FIELD SERVICE BULLETIN

FSB Number	FLCCFSB2008 - 65
Author	Guido Wuebbels
Date	Monday, March 03, 2008
Subject	GSM - MOTOROKR U9 - Battery door does not fit
Model Affected	U9
Level Of Repairs	1

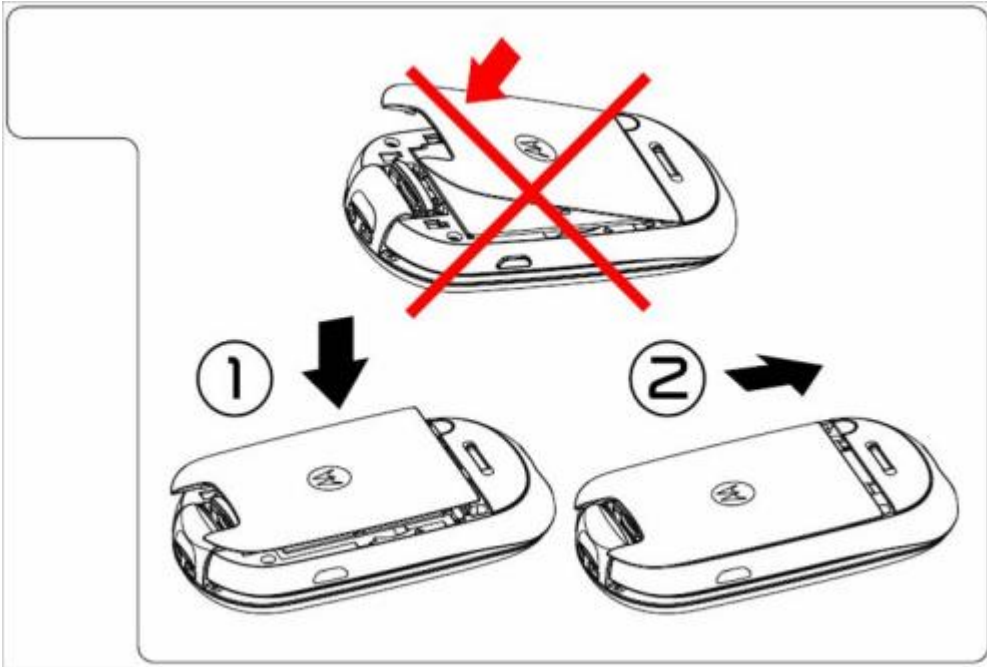
Service is aware that U9 units were returned during the NPI process with a customer complaint of "Battery door does not fit". The customer complained that it's difficult to insert the battery door. The root cause analysis reveals that the latch feature on battery door and rear housing were deformed, likely due to improper closing of the battery door by the end customer. The customer did not follow battery door closing instruction printed on the label on battery door bag and quick starter guide.

A label with instructions will be added on the top of the battery door. After first battery door insertion, the end customer will be able to remove this label.

When responding to customer inquiries or complaints related to "Battery door does not fit", please inform the customer about the correct insertion process of the U9 battery door (See above picture).
